SUBJECT: Special Field Action 01L03: Certain 2001 Econoline E350 Cutaway vehicles built at Lorain Assembly Plant – with 11,500 GVWR

Special Field Action 01L03
Certain 2001 Econoline E350 Cutaway vehicles built with 11,500 GVWR
Incorrect Rear GAWR Information

MODIFIED CERTIFICATION LABEL INSTALLATION

FIGURE 1

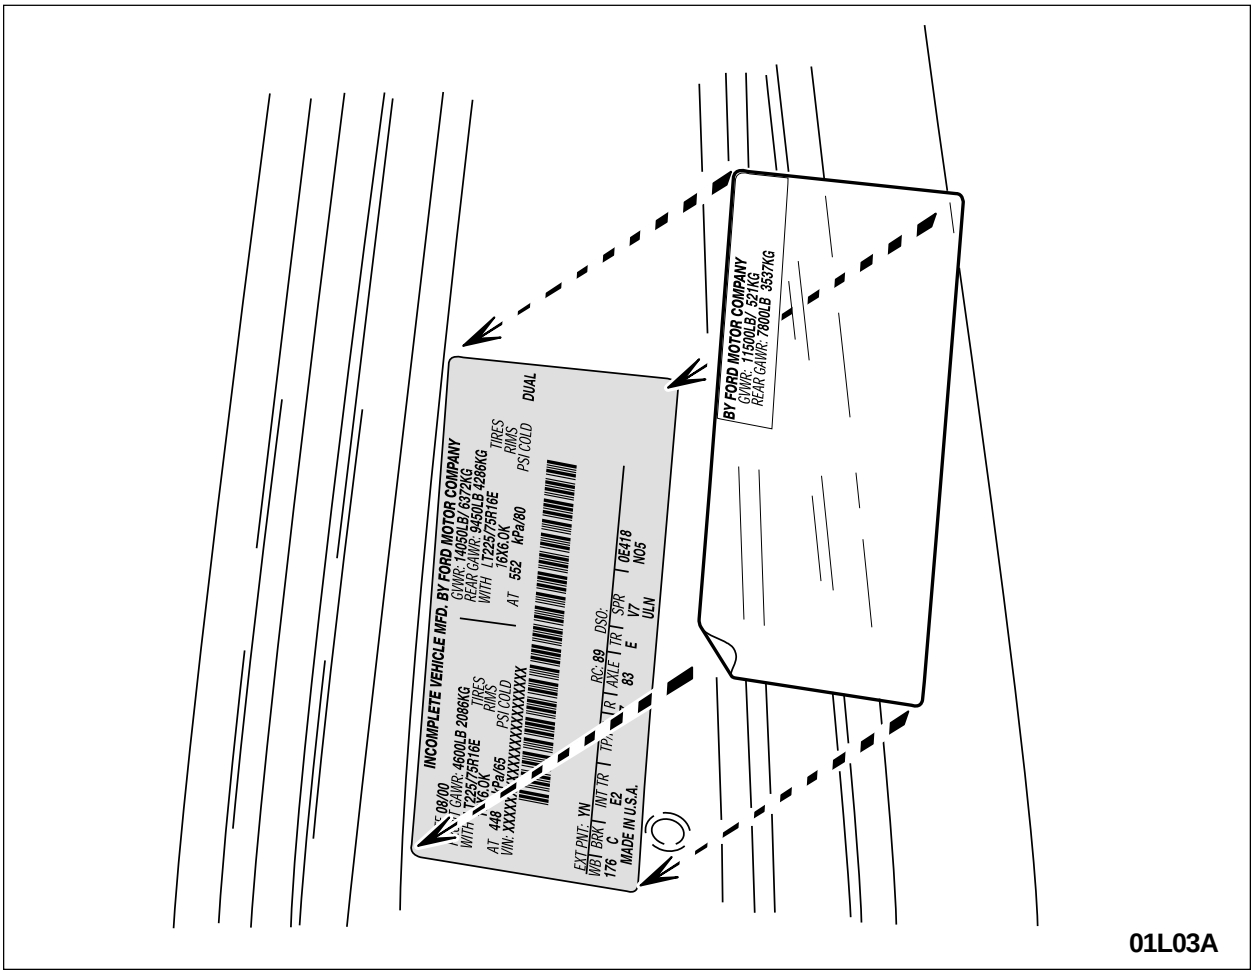
These vehicles were produced with Door Post Certification Labels that state incorrectly the rear GAWR (Gross Axle Weight Rating) is 8350lbs. The correct rear GAWR information should be 7800lbs.

1. Locate and wipe clean the original certification label on the driver's door B-pillar above the striker.
2. NOTE: To help properly align the ***new*** label over the original, the ***new*** label is the same dimension as the original and is clear except for the upper right corner which contains the revised information. Line up the outside edges and be sure the revised information covers only the words "BY FORD MOTOR COMPANY", and the GVWR and REAR GAWR ratings.

Peel the backing from the ***new*** label and very carefully position and apply the ***new*** label over the original label. See Figure 1.
